ATTACHMENT 2
TO P-90083
PROPOSED CHANGES

ATTACHMENT 3

NO SIGNIFICANT
HAZARDS CONSIDERATION
ANALYSIS

SAFETY ANALYSIS

Fig. 1

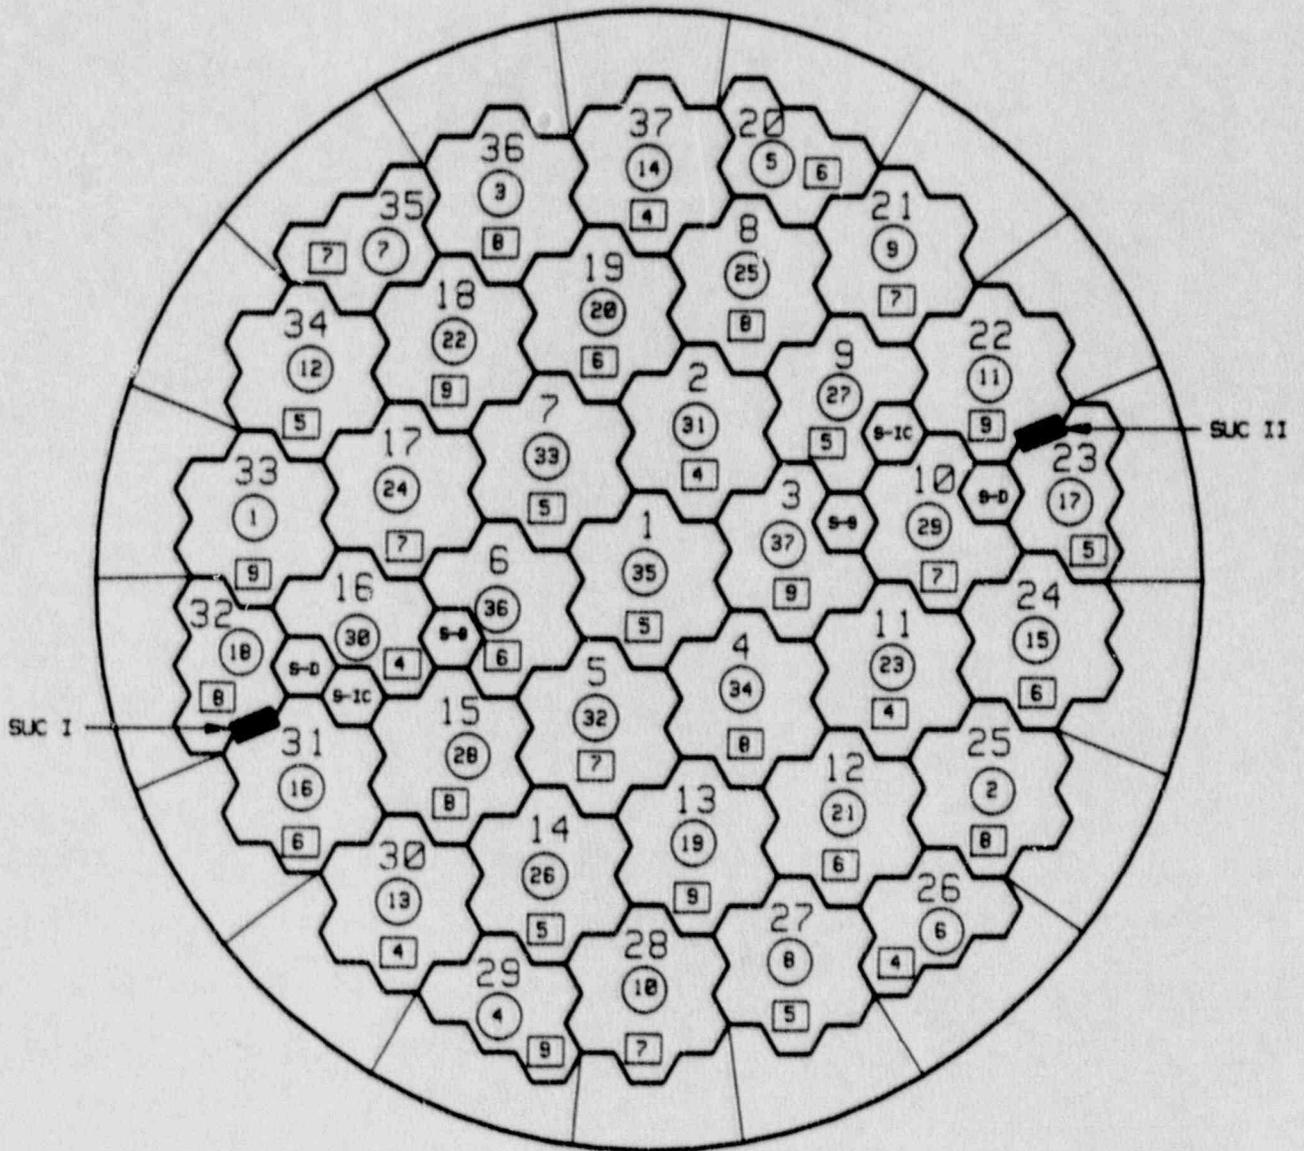
Fort St. Vrain (FSV) was permanently shutdown on August 18, 1989. By letter dated December 1, 1989, the NRC issued Amendment No. 74 to the Facility Operating License, which authorized loading of defueling elements into the core and permitted PSC to proceed with defueling. (See Figure 1 for the defueling sequence.) Currently, PSC has removed fuel from 12 core regions, and replaced fuel blocks in those regions with defueling elements.

As defueling continues past nine fueled regions remaining, a point will be reached when the remaining fueled regions and neutron sources will produce an insufficient number of neutrons to maintain the minimum specified Startup Channel count rate. (See Figure 1 for the location of the Startup Channel detectors and in-core sources.) The minimum specified count rate will then be maintained by installing small neutron sources near the Startup Channel detectors. The Startup Channels will be maintained operable per the requirements of LCO 4.7.5.
